# AURIX™ TC33xEXT errata sheet

**Marking/Step: (E)ES-AA, AA**

This document describes the deviations of the device from the current user documentation, to support the assessment of the effects of these deviations on your custom hardware and software implementations.

**Figure 2 CAN Frame with  $DLC > 4$**

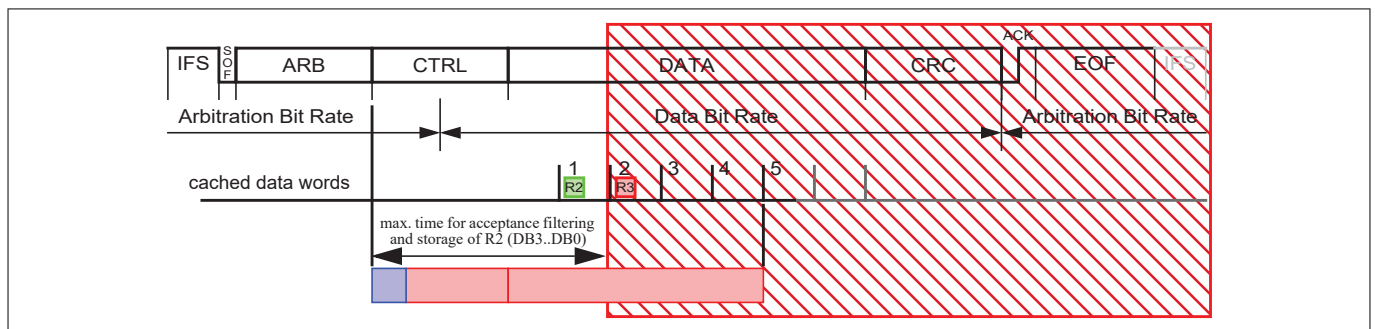
The issue may occur in FD Frame Format as well as in Classic Frame Format.

The figure that follows shows how the available time for acceptance filtering and storage is reduced.

Due to condition 3) the issue only occurs sporadically. Use an end-to-end (E2E) protection (for example, checksum or CRC covering the data field) and add it to all messages in the CAN system, to detect data corruption in received frames.

**Figure 3** Positive overload on P-pad of a LVDS RX pin pair (both used as inputs)

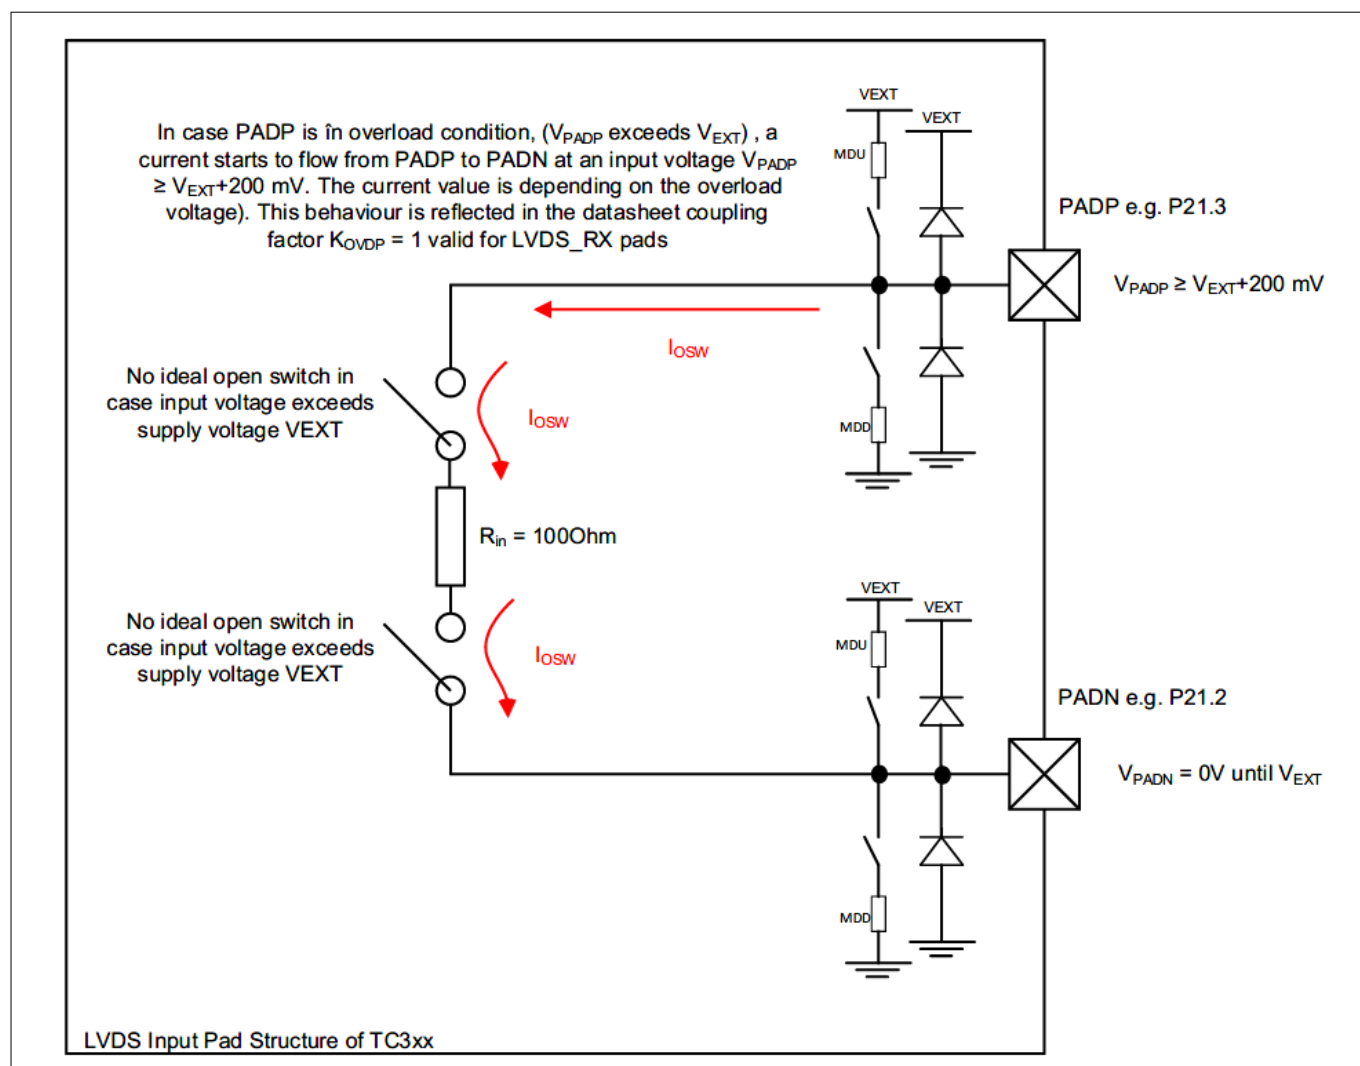
Due to the internal circuit structure, for pads with buffer type “LVDS\_RX” (see column “buffer type” in port function tables in the Data Sheet), the specified overload coupling factors  $K_{OVP}$  and  $K_{OVN}$  to the neighbor LVDS pad are relatively large (see table “Overload Parameters” in the Data Sheet).

The following figure illustrates the effect for a positive overload condition ( $V_{PADP} > V_{EXT}$ ) on the P-pad (PADP) of a pin pair where both the P-pad and the corresponding N-pad (NPAD, with  $0V \leq V_{NPAD} \leq V_{EXT}$ ) are used as digital CMOS inputs.

The overload current  $I_{OSW}$  through the non-ideal open switch significantly increases when  $V_{PADP} \geq V_{EXT} + 200 \text{ mV}$ .

**Note:** In general, the effect will also occur if the N-pad is used as output, or for a negative overload condition on either the P-pad or the N-pad.
